Corporal Arthur Nelson Play Lot Renovation Project (Fuller Street Park)  
Project Number: DPW-26-58

**ADDENDUM NO. 1**

February 3, 2026

LAYOUT & MATERIALS PLAN

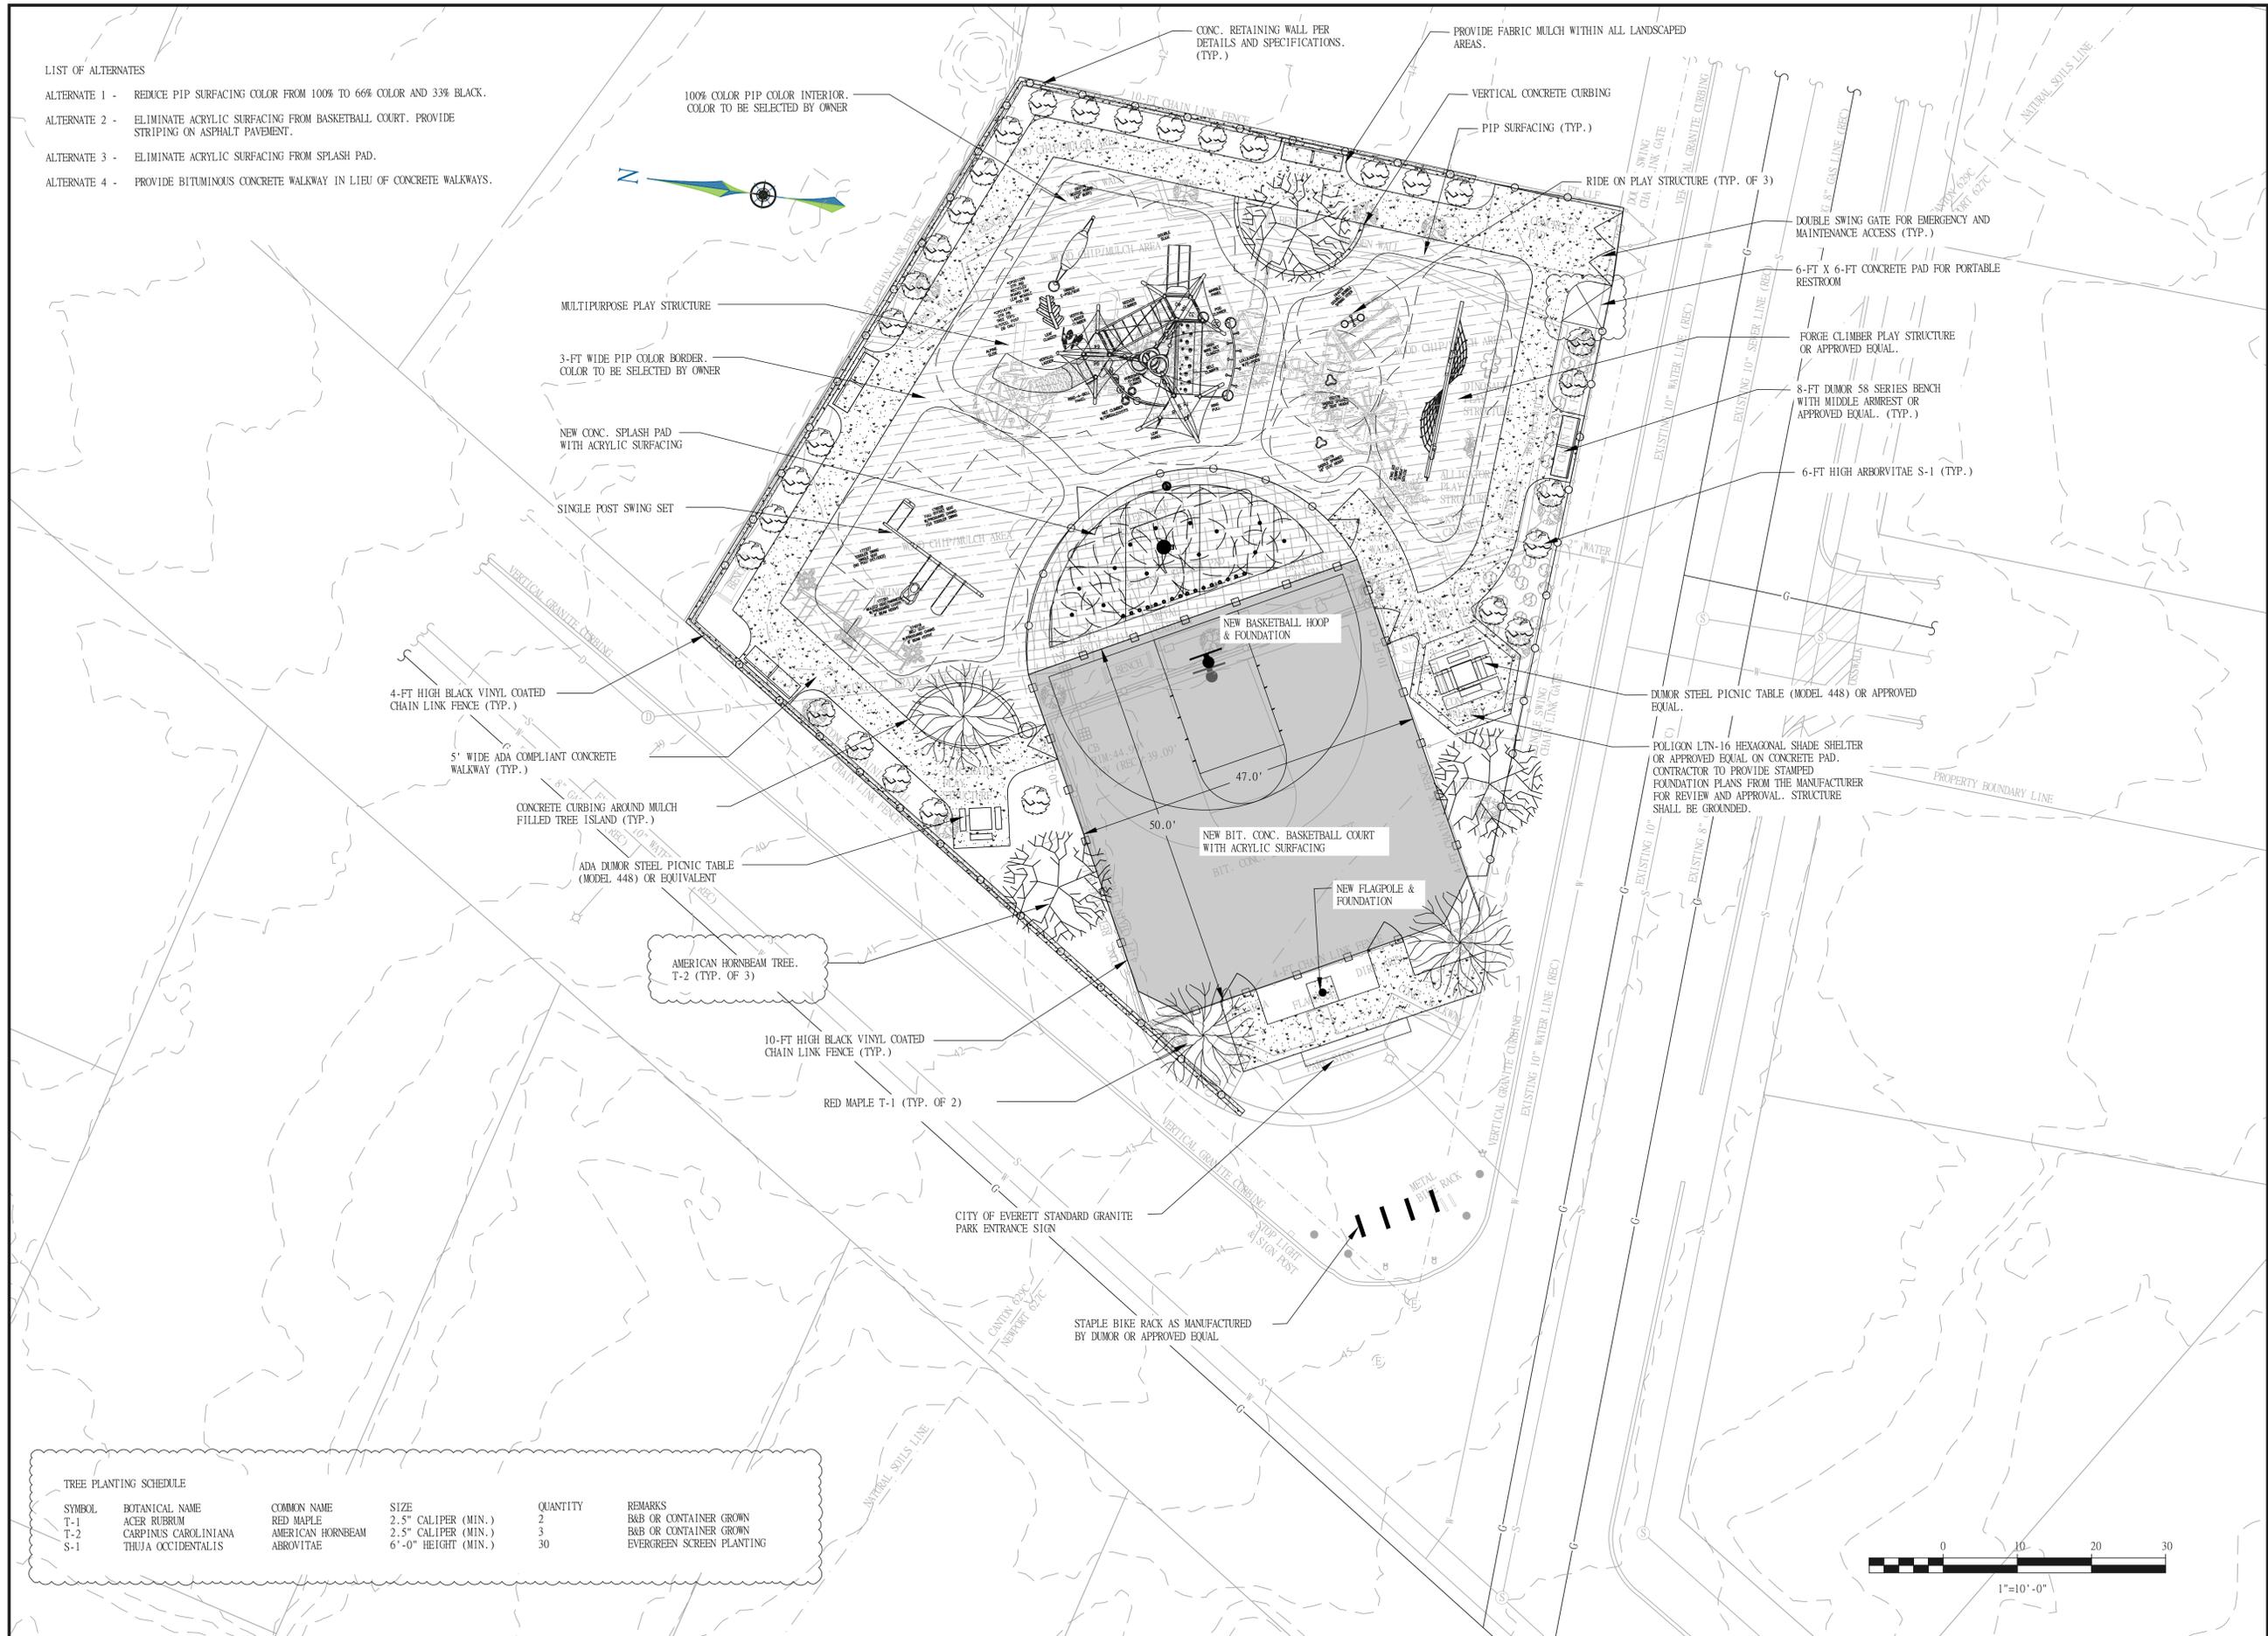
DESIGNED BY	JEFF B.	
REVIEWED BY	ARSEN H.	
1.	UPDATED TO SHOW PORTABLE RESTROOM LOCATION, PROVIDED PLANTING SCHEDULE AND FENCE CLARIFICATION	2/2/26
NO.	REVISION	DATE

**DRAINAGE & UTILITY PLAN**

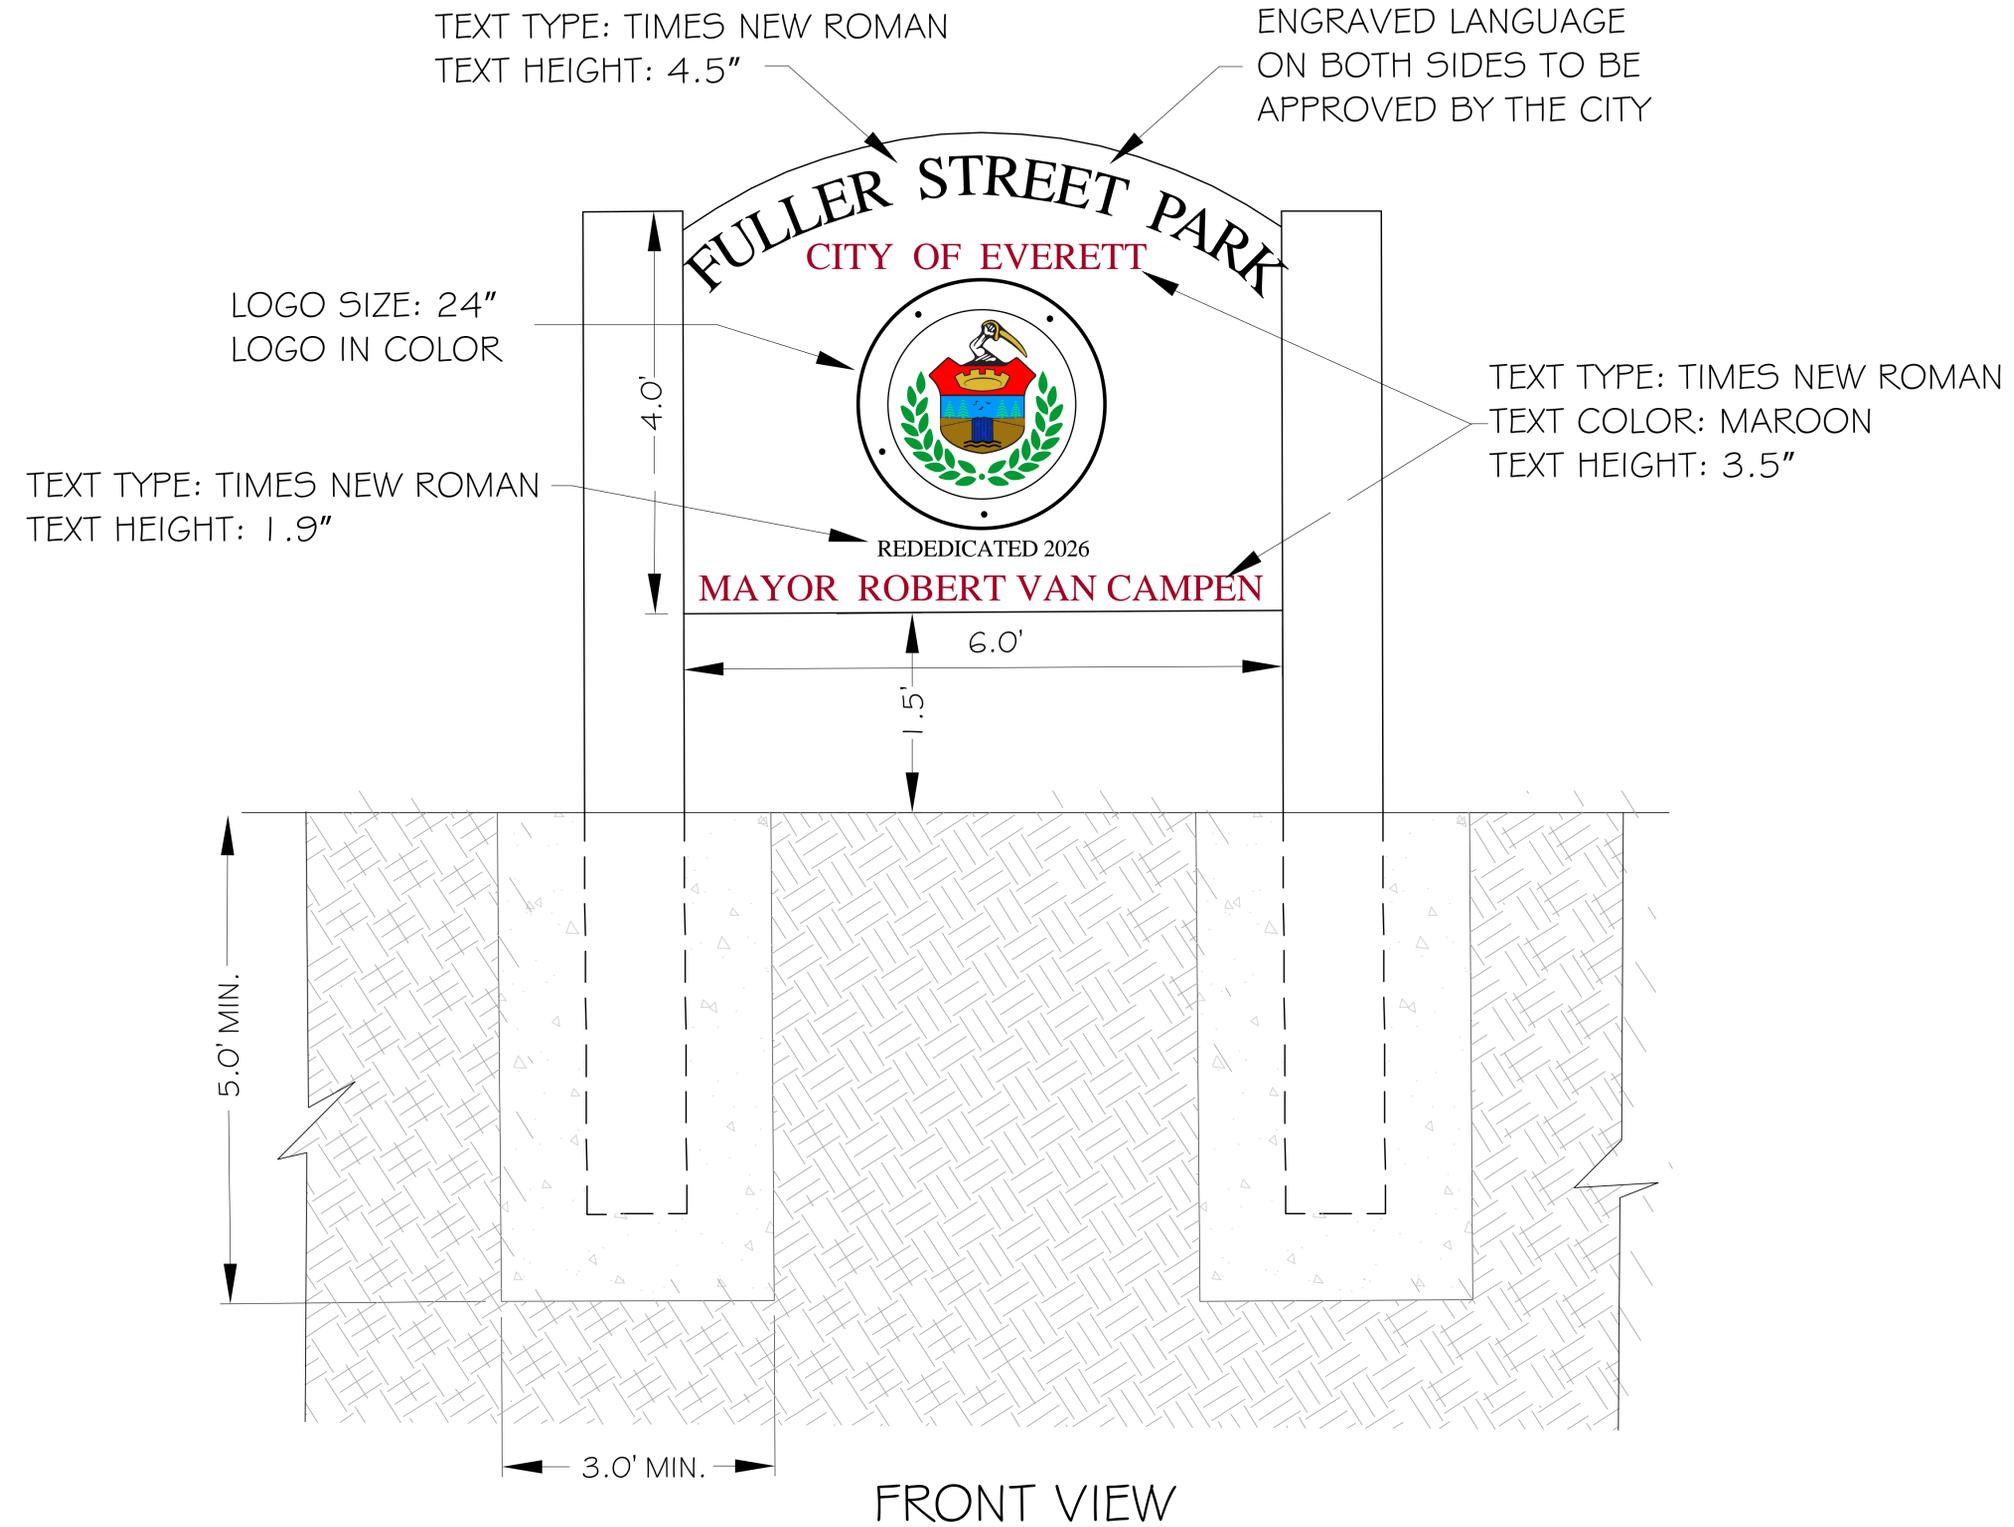
NO.	REVISION	DATE
1.	UPDATED TO SHOW DRAINAGE INFRASTRUCTURE.	2/2/26
